ADDENDUM NO. 2

To the Drawings and Project Manual dated 16 June 2017

**TAS/ADA FIRE MARSHAL
DEFERRED MAINTENANCE PROJECTS
MIDWESTERN STATE
UNIVERSITY**

SECTION OF TYPE "F" SLOPED GLAZED OPENING

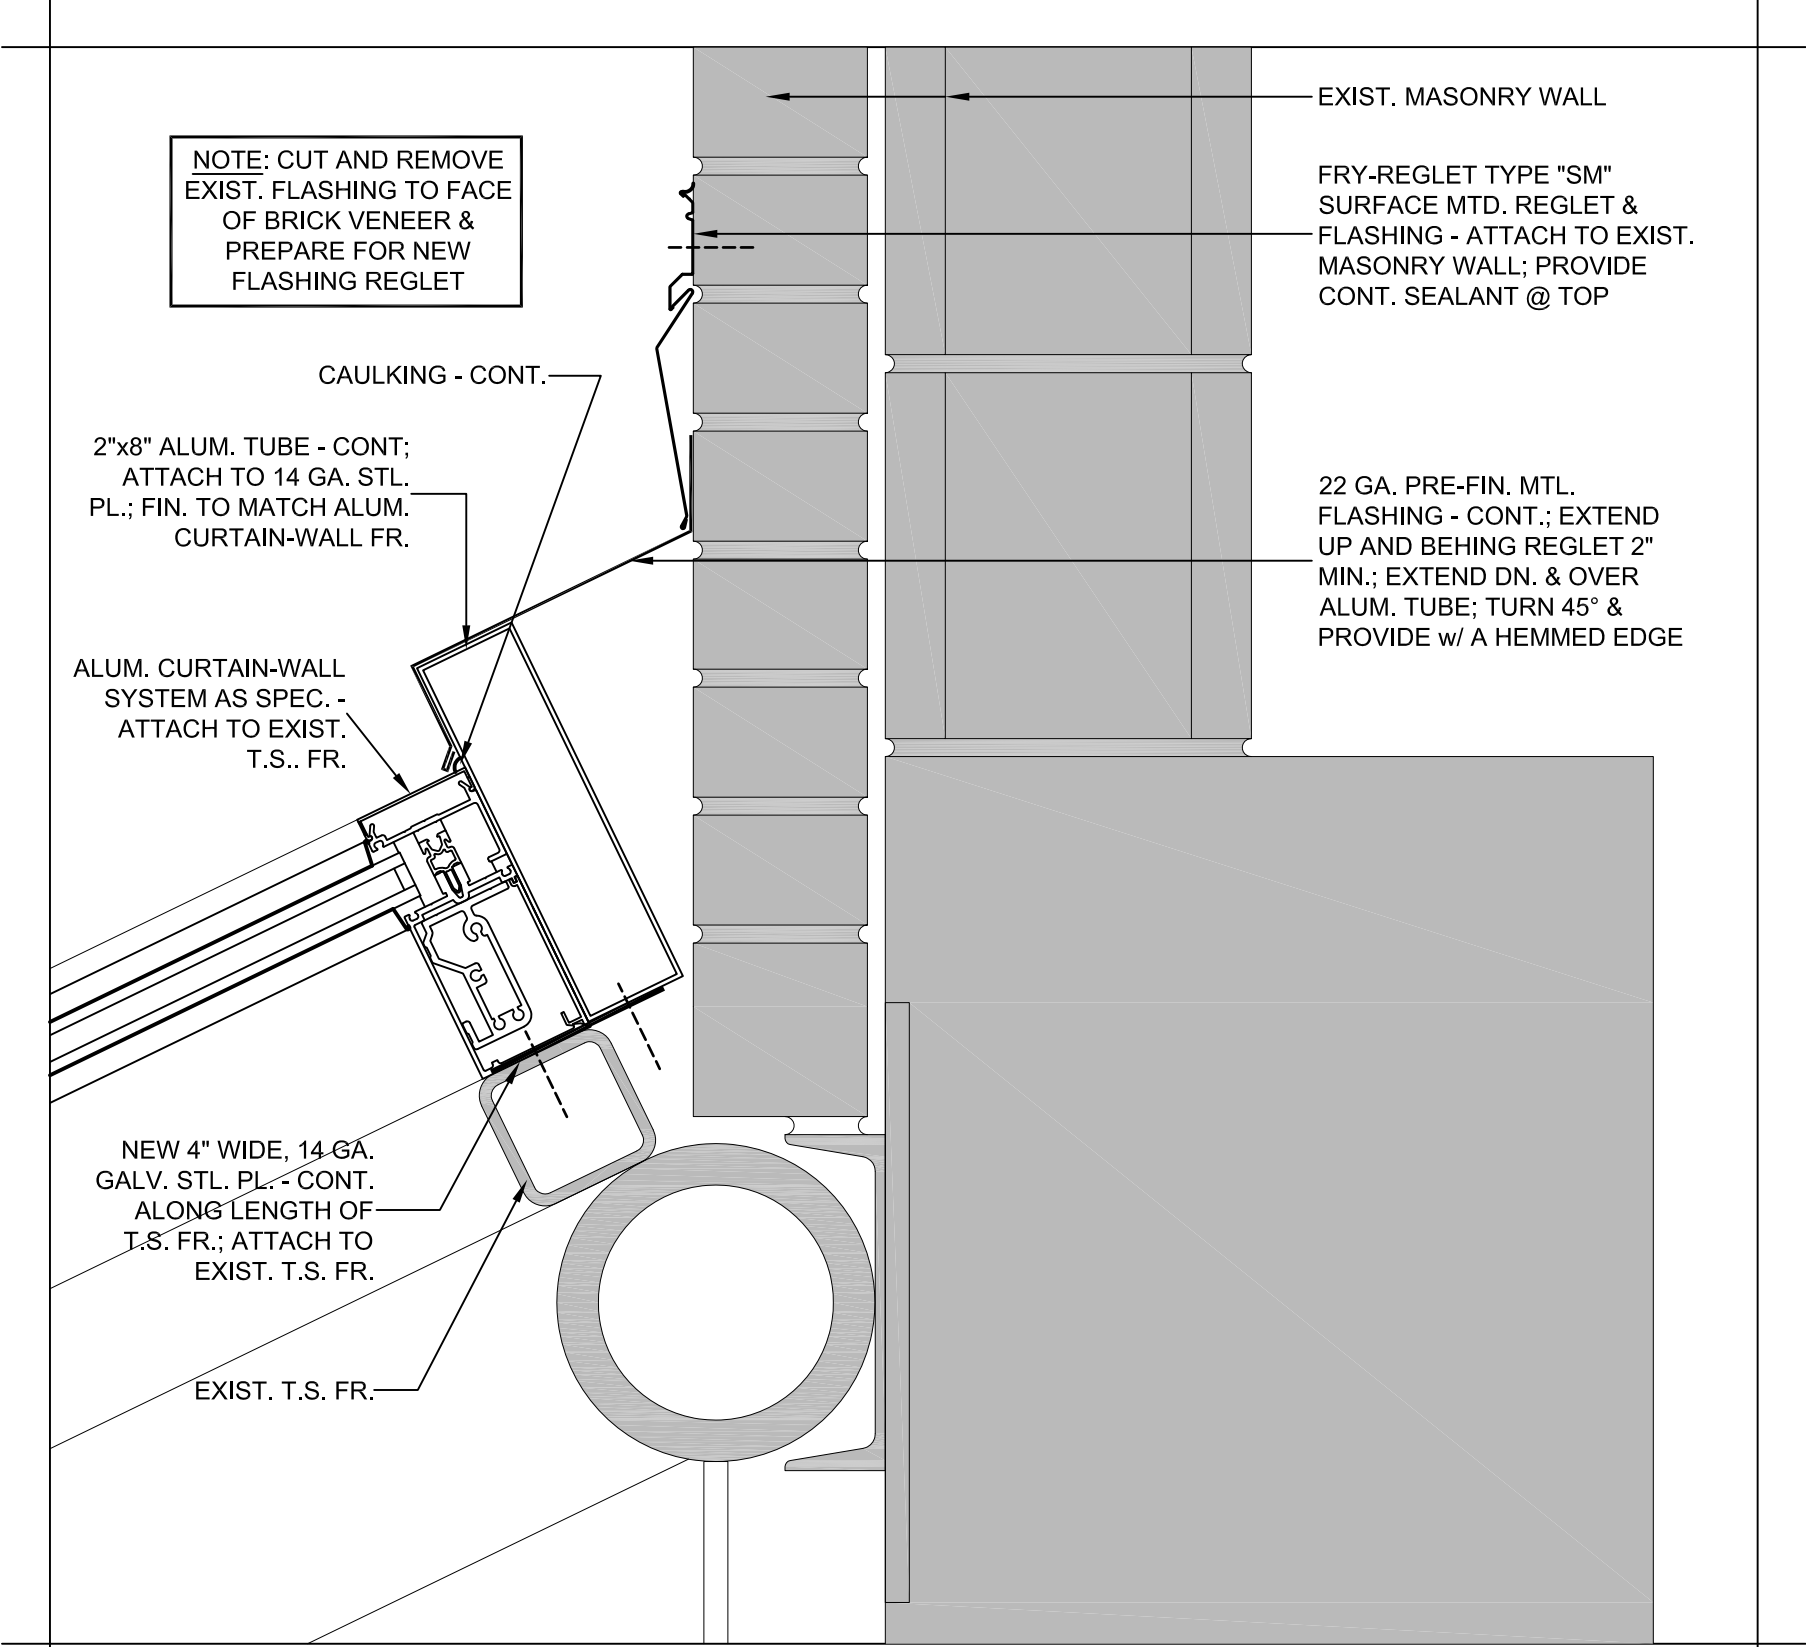
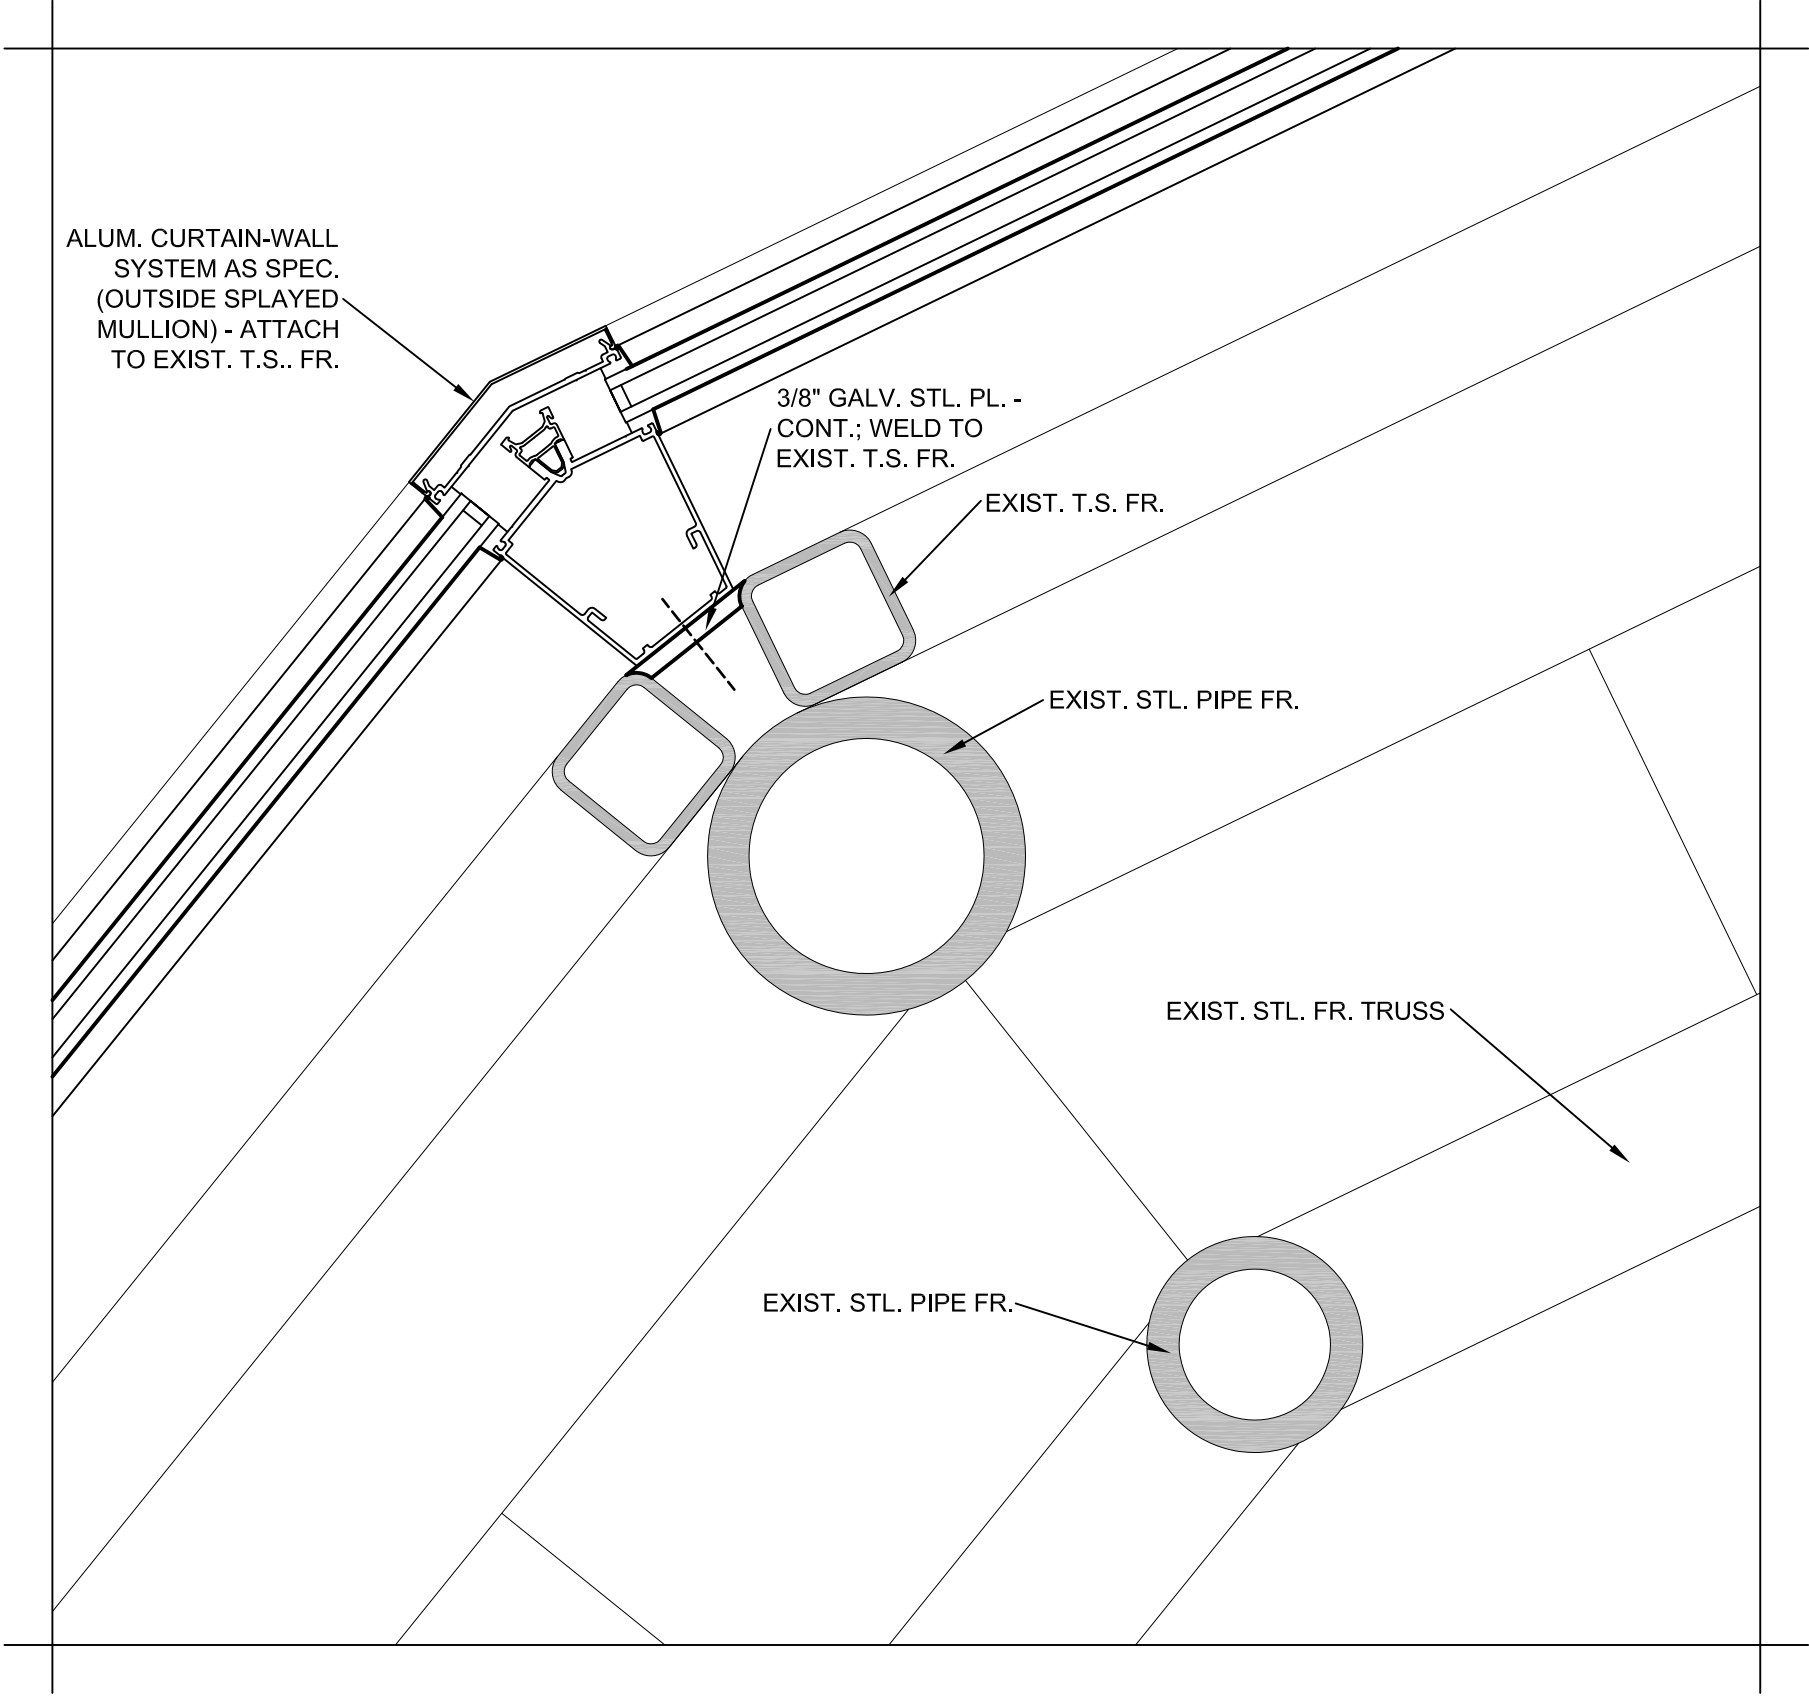
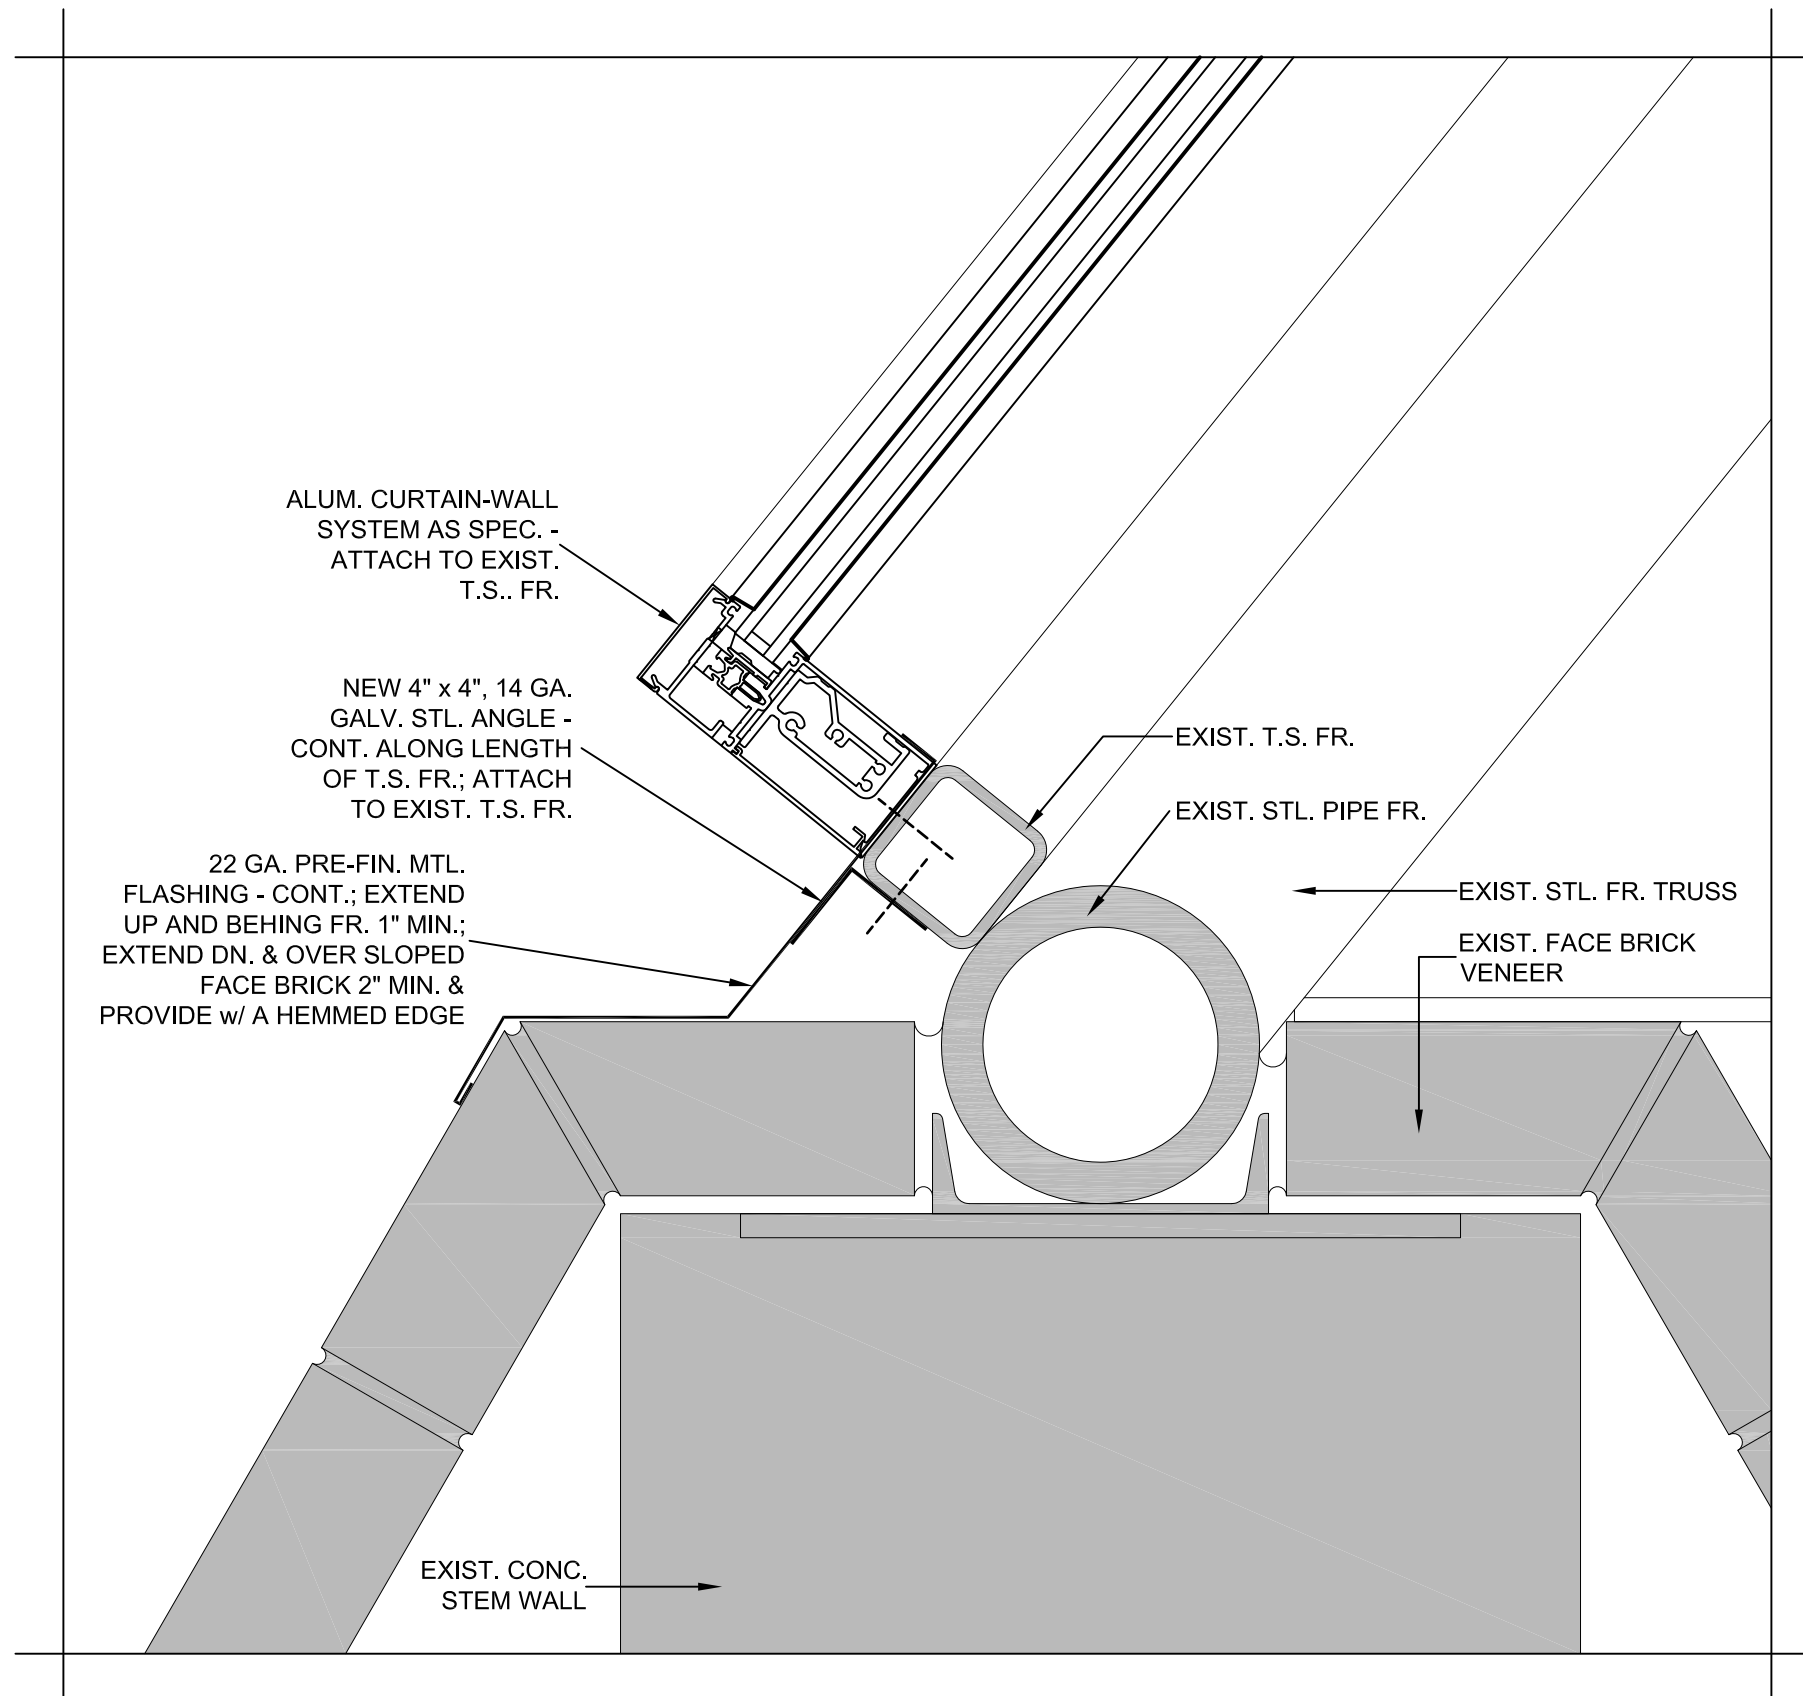
ADD: An **Alternate #3** which shall be all work associated with the removal of the existing sloped glazing system (existing steel tube joists and steel tube/pipe framing are to remain in place) and the provision of the new sloped glazing system (Opening **#FF21**) as indicated.

DELETE: On Sheet “**A502**”, the opening details “**A502-18**” as indicated.

ADD: Opening details “**A502-18**” as indicated on Supplemental Drawings “**AD#2-01**” through “**AD#2-05**” attached with this Addendum.
